UNITED STATES
DEPARTMENT OF THE INTERIOR
BUREAU OF LAND MANAGEMENT
Sundry Notices and Reports on Wells

PLUG AND ABANDONMENT PROCEDURE

Federal 1-22 #1

Re: Permanent Abandonment
Well: 1 Federal 1-22

Proposed P&A

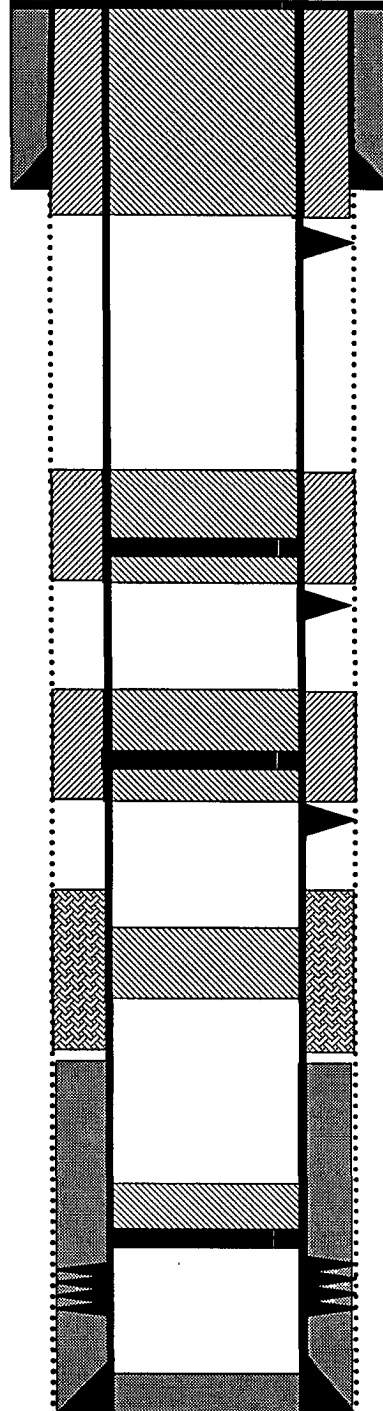
1. Plugging operations authorized are subject to the attached "General Requirements for Permanent Abandonment of Wells on Federal and Indian Lease."
2. Farmington Office is to be notified at least 24 hours before the plugging operations commence (505) 599-8907.
3. The following modifications to your plugging program are to be made:
 - a) Bring the top of the Gallup plug to 5300'.
 - b) Place the Mesaverde plug from 2898' – 2798' inside and outside the 5 ½" casing.
 - c) Place the Pictured Cliffs/Fruitland plug from 2080' - 1748' inside and outside the 5 ½" casing.
 - d) Place the Kirtland/Ojo Alamo plug from 1601' – 1327' inside and outside the 5 ½" casing.

7. **Plug #4 (Kirtland and Ojo Alamo tops, 1515' - 1255')**: Perforate 3 squeeze holes at ~~1515'~~ ¹⁶⁰¹. Attempt to establish rate into squeeze holes if the casing tested. Set 5.5" cement retainer at ~~1465'~~ ¹³²⁷. Establish rate into squeeze holes. Mix and pump ~~118~~ ¹⁶⁰¹ sxs cement, squeeze ~~78~~ ⁷⁸ sxs outside the casing and leave ~~37~~ ³⁷ sxs inside casing to cover through the Ojo Alamo top. TOH and LD tubing.
